**DEVELOPMENT ASSESSMENT UNIT**  
**Minutes of the Development Assessment Unit**  
**Shire of Augusta Margaret River**  
**On Tuesday 11 May 2021**

**Proposed Chalets (Four Chalets)  
456 (Lot 103) Treeton Road, North Treeton**

**Proposed Rural Industry (Compost Facility) & Dams (2 x Leachate Storage Dams)  
279 (Lot 1) Boodjidup Road Margaret River**

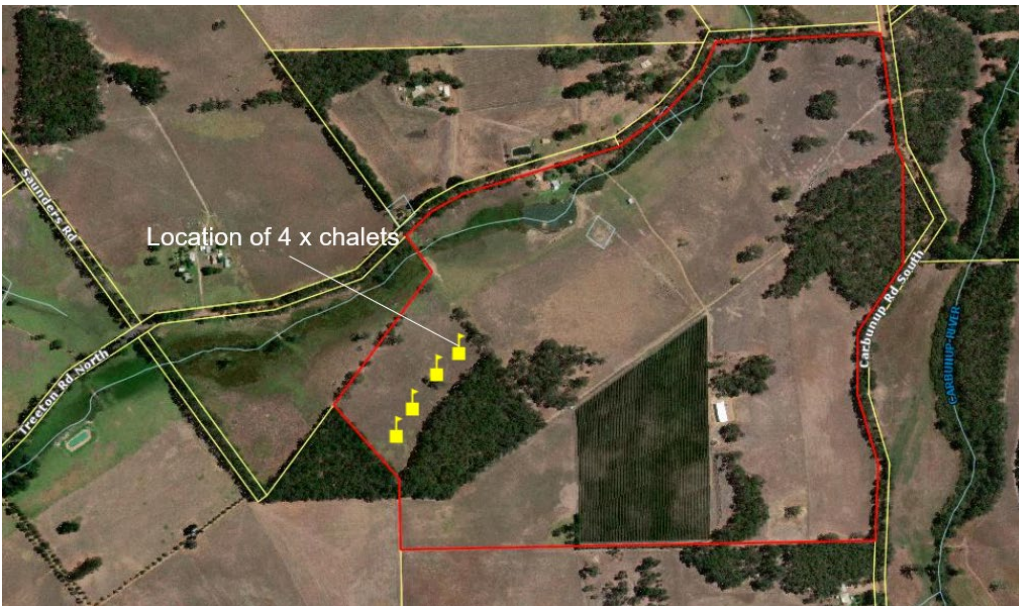
<b>Agency Comments</b>		<b>Officer Comment</b>	
<u>Department of Fire and Emergency Services (DFES)</u> <ul style="list-style-type: none"> <li>Review vegetation classification</li> <li>Comments in relation to evacuation are to be within the Bushfire Emergency Evacuation Plan (BEEP) not the BMP.</li> <li>Review location requirements.</li> <li>Requirements for private road network given that the accommodation will be for long term and short term basis.</li> <li>Address water supply and location within a BAL 29.</li> </ul>		Noted. These comments have been assessed by the Shire Emergency Services Officer (see comments below). The BMP has subsequently been amended to address both DFES and Emergency Services comments and the amended BMP is considered to be acceptable.	
<b>Internal Department Comments</b>		<b>Officer Comments</b>	
<u>Infrastructure</u> New crossover proposed, which will require assessment prior to construction. Support with recommended conditions and advice notes.		Noted, conditions added.

<u>Health</u> No concerns raised, supported with recommend conditions and advice notes.		Noted, conditions added.	
<u>Emergency Services</u> Have reviewed the comments made by DFES and provide the following advice. <ol style="list-style-type: none"> <li>Comments made about the BEEP, not an issue if the comments provided in the BMP are replicated in the BEEP.</li> <li>Agree with DFES on location; there are areas on site with much lower risk, however the application meets the Guidelines.</li> <li>Would be happy with a 4m wide 6m horizontal clearance (as a private driveway) through the grassland. Recommend driveway continues between chalets.</li> <li>Need an APZ around water tank.</li> </ol>		<ol style="list-style-type: none"> <li>Noted, no changes required.</li> <li>Noted, no changes required given that the location of the chalets complies with the Guidelines and a BAL 19 – 29 is able to be achieved without the removal of vegetation.</li> <li>Revised BMP reflects these comments and a 4m wide 6m horizontal clearance will be achieved for the driveway. The driveway has been extended to connect to each chalet (see figure 2 below).</li> </ol>

<p><u>Environment</u> Not clear if clearing of vegetation is required to create the access.</p>	 <p>Figure 2: Extract from BMP</p> <p>4. Location of water tank revised in the BMP and an APZ is shown around the water tank (see Figure 2 above).</p> <p>Noted. The BMP states that <i>'no modification to remnant vegetation is required as part of this proposal'</i>. Notwithstanding, a condition is recommended to be applied that requires additional details about the location of the access to ensure no vegetation is required to be removed.</p>
---	--
